RFI Response | Mixed –use precinct with affordable housing – Crescent Parklands, Holroyd (SSD –70283710)

This letter relates to State Significant Development Application SSD–70283710 for the proposed mixed-use precinct development, including seven residential tower buildings, an eastern mixed-use podium and associated car parking at 1 Cresnet Street, Holroyd (the site).

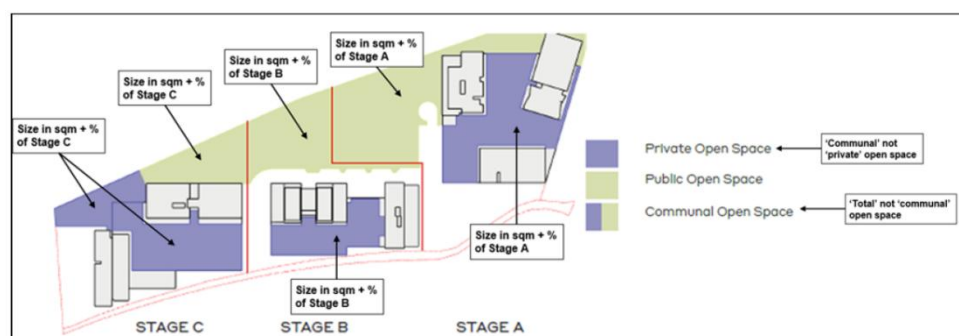
2. The response did not provide a clarified breakdown of the open space calculations as requested. See annotated image below.

A clear break down of the open space calculations has been provided by Woods Bagot, refer to Appendix A.
